**DEPARTMENT OF PUBLIC WORKS
COUNTY OF HUMBOLDT**
MAILING ADDRESS: 1106 SECOND STREET, EUREKA, CA 95501-0579
AREA CODE 707

LAND USE DIVISION INTEROFFICE MEMORANDUM

RE: SUBDIVISION REQUIREMENTS - IN THE MATTER OF THE APPLICATION OF KRAMER PROPERTIES, APN 017-032-003, APPS 9902, FMS 15-004, PDP 15-001, GPA 15-005, AND ZR 15-008 FOR APPROVAL OF A TENTATIVE MAP, CONSISTING OF 81 ACRES INTO 156 LOTS

DATE: 12/27/2021
01/06/2022 Revised
03/14/2022 Revised (typographical error corrected)
02/15/2023 Revised per Board of Supervisors Meeting 3/22/2022

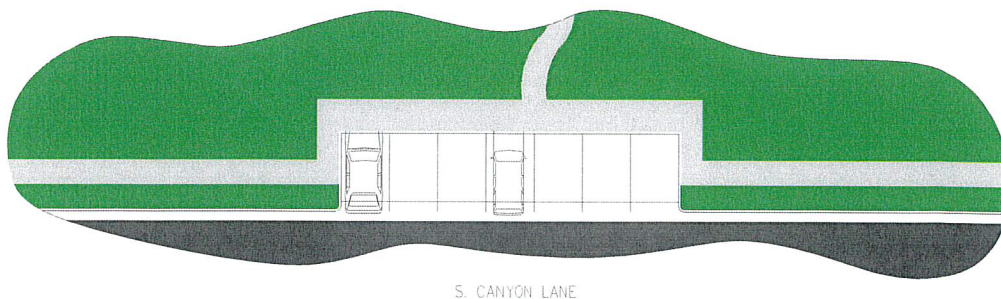
Lot 20 Trail Connection: The applicant shall dedicate to the County of Humboldt a 20 foot wide easement for public trail/sidewalk purposes between Lots 19 and 20 to connect Oakview Drive with the McKay Community Forest Trail.

Lots 44/45 Trail Connection: The applicant shall dedicate to the County of Humboldt a 20 foot wide easement for public trail/sidewalk purposes between Lots 44 and 45 to connect Oakview Drive with the McKay Community Forest Trail.

In the event that a trail connection between Lots 42/43 cannot be developed to the satisfaction of the Department, a trail connection on Lots 28/29/30 shall be provided. This shall be resolved at the time that Phase 4 or Phase 6 is developed, whichever occurs first.

It is intended that this easement would overlap the drainage easement. This shall be dedicated in manner and location as approved by this Department.

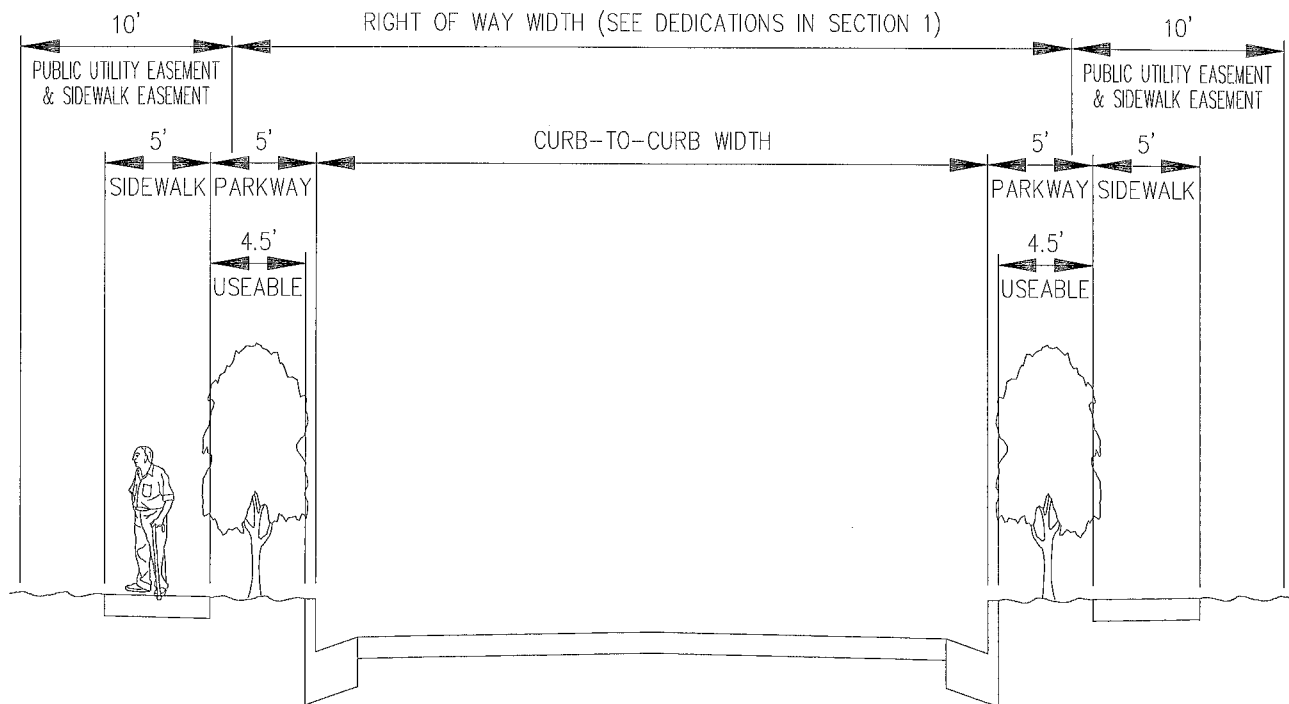
- (d) **REDWOOD STREET (OFFSITE):** Applicant shall construct in-fill sidewalks along the north side of Redwood Street between Walnut Street and the subject property. Applicant shall construct Class 2 bike lanes on Redwood Street from Walnut Drive to the subdivision boundary. This shall be completed with the phase that connects to Redwood Street.

Prior to filing the subdivision map with the County Recorder for the last phase of the project, the applicant shall submit a speed hump petition to the Department of Public Works. If the speed hump petition is approved, the applicant shall construct speed humps prior to filing of the subdivision map.

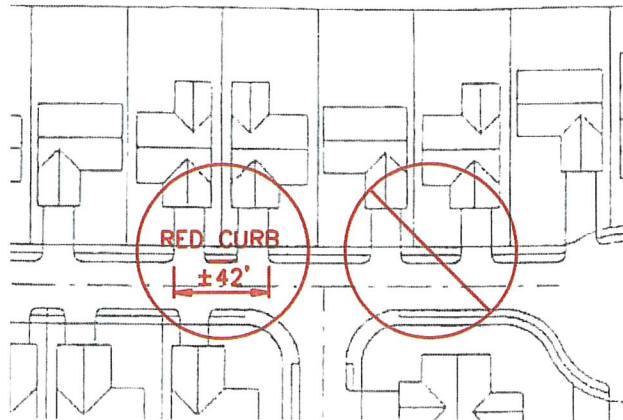
A 5 foot wide sidewalk with 5 foot wide landscape strip (4.5 foot wide useable) shall be constructed along both sides of the roads. Caltrans Type A2-6 PCC curb and gutter shall be constructed on both sides of the roads. ADA facilities shall be constructed at all intersections.

When feasible, curb returns on local roads shall be bulbed out into parking lanes at intersections.

Both marked and unmarked crosswalks shall be constructed in PCC.

Wherever feasible, driveways shall be placed back-to-back to provide ± 42 foot long "turnouts" for standard two-car wide (18 foot wide) driveways. [± 26 foot long "turnouts" are provided with one-car (10 foot wide) driveways]. See the diagram below: The circle on the left represents the ideal condition with back-to-back driveways; the circle on the right represents the condition that should be avoided.

STANDARD PARKING STALL WITH WHEEL STOP

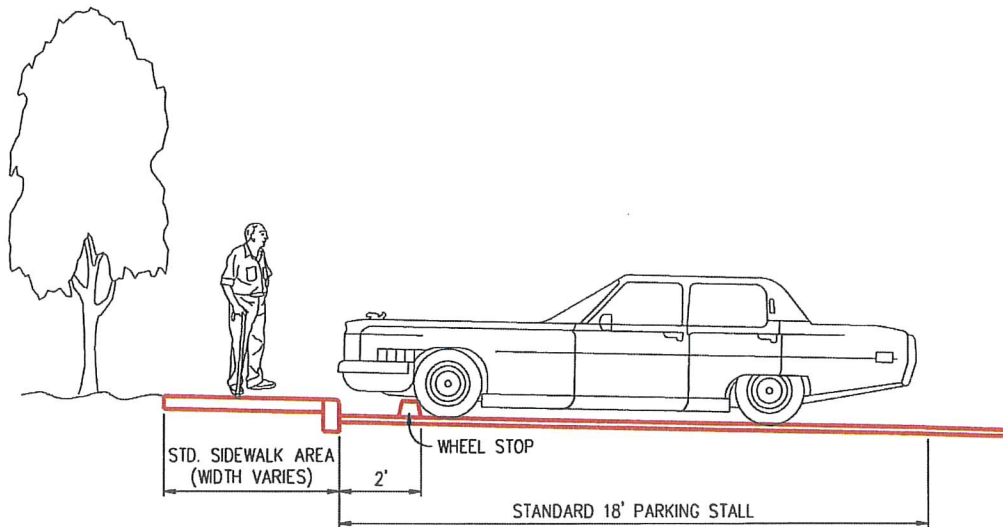
Parking stalls are typically 8 feet wide x 18 feet long. When sidewalk is placed in front of a parking stall, wheel stop blocks are required. In lieu of wheel stop blocks, the length of the parking stall may be reduced by 2 feet and the width of the sidewalk increased by 2 feet so that the curb acts as a wheel stop.

Above: Cross section for trails within the subdivision

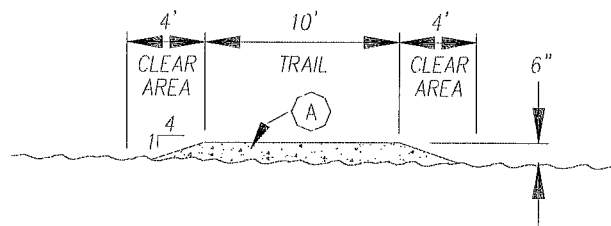
2.8 **TRAILS:** Applicant shall construct trail connections to the McKay Community Forest Trail. The trail connections shall extend from the sidewalk on the subdivision road to the McKay Community Forest Trail. This will include some off-site trail work on the McKay Community Forest property. A permit from the Department of Public Works will be required to perform work on County property. Within the subdivision, the trail shall be ten (10) feet wide, with 4:1 slope bladed shoulders and overlapping 4 foot wide clear area on each side. Within the McKay Community Forest, the trail shall be ten (10) feet wide, but may be reduced in trail width and clear area width to accommodate existing features, as approved by the Department. Removable bollards installed to the satisfaction of the Department are required at all trail access points to the Mc Kay Community Forest to prevent vehicular access. The structural section of the trail shall be as follows:

- A= 3" of Caltrans Type B Hotmix
- B= 6" minimum of compacted Caltrans Class 2 aggregate base
- C= Additional excavation and placement of 12 to 18" of compacted coarse river run (or pit run rock) and fines may be required by the Department depending upon soil conditions.
- D= shoulder backing consisting of crusher fines.
